ACCESSION NBR: 8303240210 DOC. DATE: 83/03/18 NOTARIZED: NO DOCKET #
 FACIL: 50-389 St. Lucie Plant, Unit 2, Florida Power & Light Co. 05000389
 AUTH. NAME AUTHOR AFFILIATION
 UHRIG, R.E. Florida Power & Light Co.
 RECIPIENT NAME RECIPIENT AFFILIATION
 EISENHUT, D.G. Division of Licensing

SUBJECT: Forwards addl info to clarify aspects of auxiliary feedwater pump endurance test rept, per commitment in SER.

Re: ST. LUCIE UNIT NO. 2
DOCKET NO. 50-389
AFW ENDURANCE TEST REPORT
REQUEST FOR ADDITIONAL INFORMATION

AFW ENDURANCE TEST REPORT

Equipment 2A Aux Feed Pump

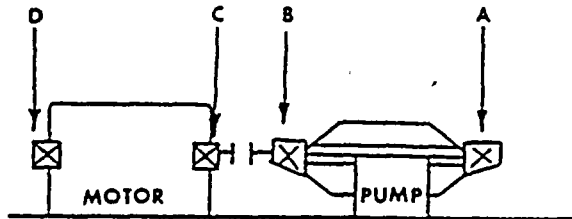
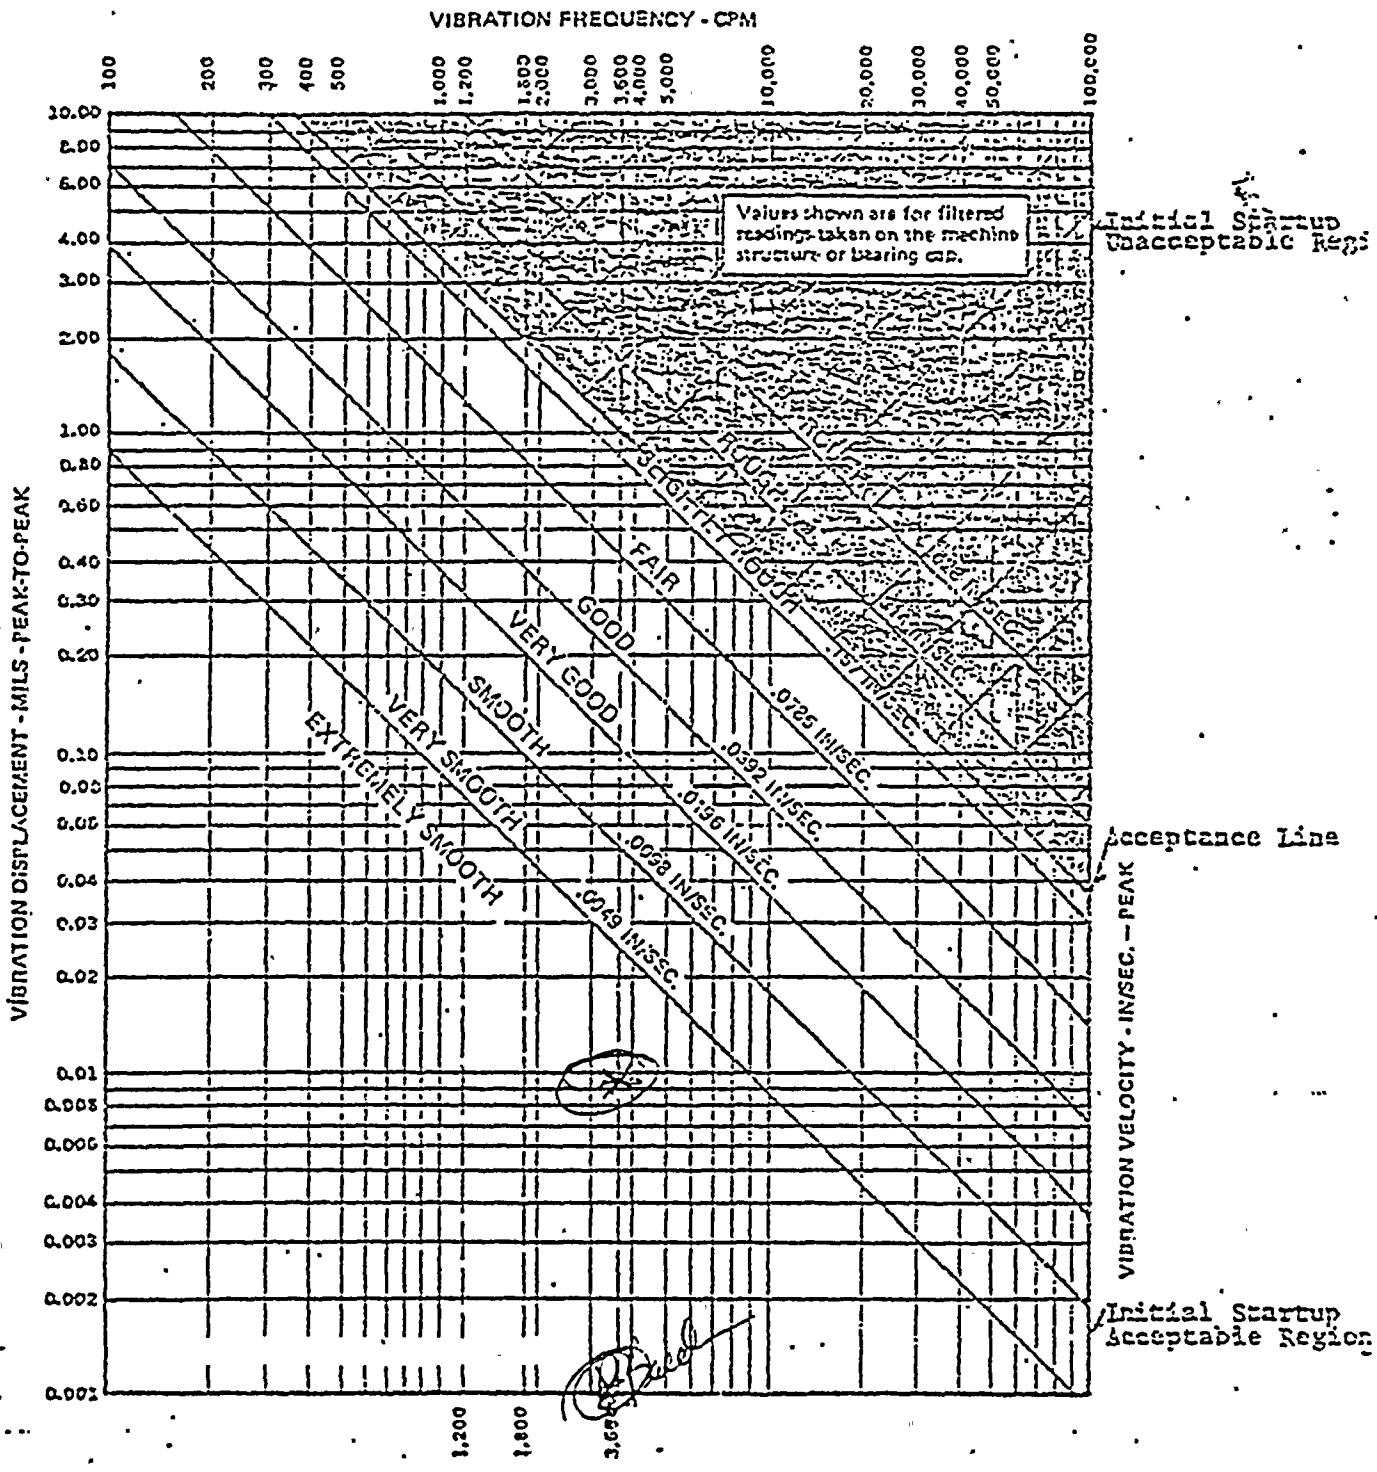
- 2) REQUEST: Provide AFW pump vibration data taken during the test.
RESPONSE: During the AFW endurance test, Florida Power and Light recorded vibration of the pumps in accordance with Florida Power and Light's approved procedures on vibration monitoring.

The recorded data and acceptance criteria for each pump is contained in Attachment 1. The data demonstrates that the vibration levels did not exceed allowable limits established by the vibration severity charts.
